AMENDMENT UNDER 37 C.F.R. § 1.111
U.S. Application No.: 09/787,139

Attorney Docket Q63452

AMENDMENTS TO THE DRAWINGS

b. Present Claim 23

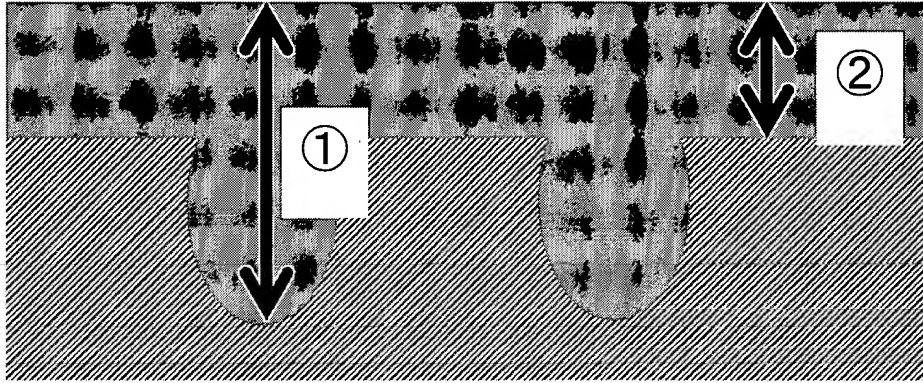
Moreover, the present invention is different from Greschner in terms of the thickness of the electroless plated film. Specifically, the electroless plated film of the present invention is thicker in convex areas and thinner in concave areas of the roughened surface. In contrast, as shown below, the electroless copper layer 7 of Greschner is thinner in convex areas (②) and thicker in concave areas (①). With such a constitution, when the electroless copper layer is etched, the layer in the concave areas (①) cannot be completely etched.

According to the present invention (claim 23), the electroless plated film is complementary to a surface of the roughened surface of the resin insulating substrate board. Thus, the conductor circuit does not have blistering.

Further, the electroless plated film in convex areas of the roughened surface is relatively thicker than the electroless is plated film in concave areas of the roughened surface. In the

etching step, etching solution tends to fail to reach sufficiently to concave areas. Since the electroless plated film in concave areas is thinner, it can be readily and completely stripped off and do not leave unetched residues, so that high inter-conductor insulation dependability is assured even if space between conductor circuits is narrow (see page 38, lines 15 to 20 of the present specification).
